**Hampstead Residents CLG. (Ref:- Submission No 111/Case 314724)**

**Our submissions at An Bord Pleanála (ABP) Metrolink Oral hearing 21/2/24.**

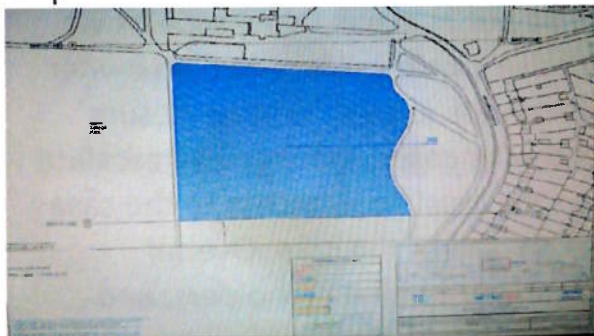
We welcome the TII/NTA clarification that the blue areas do not relate to removal of any trees or hedges, in the TII/NTA maps (Ref Map A&B item 16) and that we had attached to our submission. We acknowledge that TII/NTA have stated that no trees along the Hampstead Avenue boundary are planned to be removed (Ref:- Map A and B in item 16 below) .

However we would require that the word 'planned' is removed from the statement...and revised as:- "No trees along the Hampstead Avenue boundary, and the blue area (maps indicated in Item16) will be removed." We ask the Inspector to place this condition in the RO.

Map A

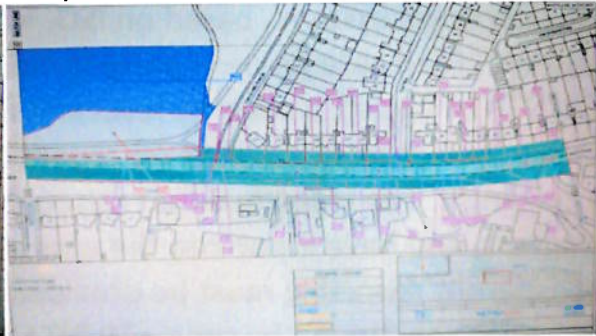
In this section where we referred to the Construction Report (page 94 and 95 of Vol.5, Chapter 5, A5.3). TII/NTA have chosen not to respond to our request, that a condition be placed on the use of lands in 'blue shaded areas' (Map A) in the above mentioned report. We requested in our submission that any of the **soil impacts** to park lands that are indicated by TII/NTA in maps and specifically allocated for football field re-alignment (according to TII/NTA) ...is only for football field re-instatement (Map A). This land should not at any stage be used for temporary construction, storage, support uses etc for a Metrolink facility that may occur in Albert College Park.

In previous communications, TII/NTA themselves have stated the above indicated Map A, is only for football field re-instatement, however TII/NTA have chosen not to respond to our request for this clarification in our submission. We ask the inspector to include this as a specific RO condition.
